SANI-CEPTOR® ACID RESISTANT COATED FLOOR & INDIRECT WASTE DRAINS

Shop Drawing Submittal Review

Project Name: Webster University-**ISB**

Copies	No.	Description
1 PDF	221319P01	(Submittal No.'s)
		(Cannon #22 1319-002) - (Paric #15051-) – (WES #607)
		➢ **Sanitary Specialties Product Data:**
		• Wade Floor Drains: FD-1, FD-2, FD-3
		• Wade Floor Sinks: FS-1, FS-2
		• J.R. Smith Floor Sinl: FS-3
		• Wade Floor Cleanout: FCO-1
		• Wade Wall Cleanout: WCO-1, WCO-2

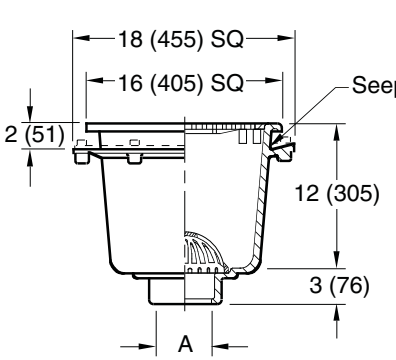
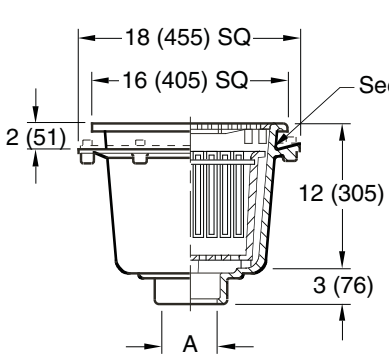
Specified to include trap guard seal device. Refer to drawing P0601, Addendum 2-4, dated 24 May 2016
